# Access Compliance Report

## Public Rights-of-Way

Intersection ID: 52613	Main Street: GRAHAM RIDGE DR	Cross Street: HERITAGE POND DR	Location: N
ADA ID: 2CB02422D430	Ramp Type: Directional1	Initial Pass/Fail: Pass	Overall Compliance: No
		Severity Score: 0

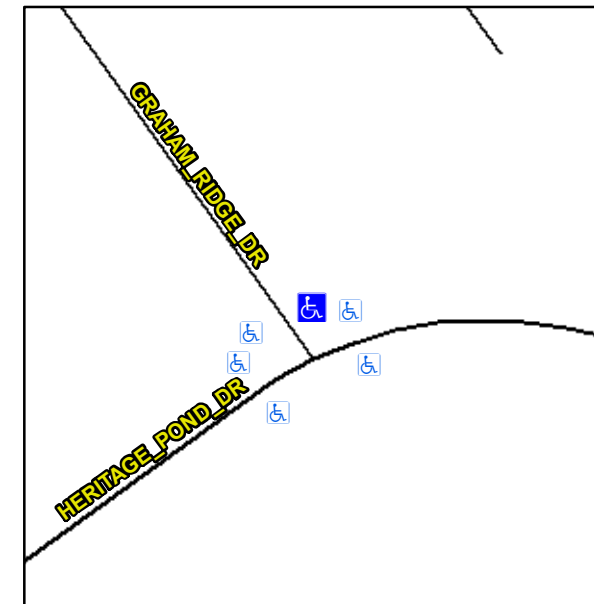
**R304.2.2-Perp, R304.3.2-Para**

**Remove & Replace Landing.**
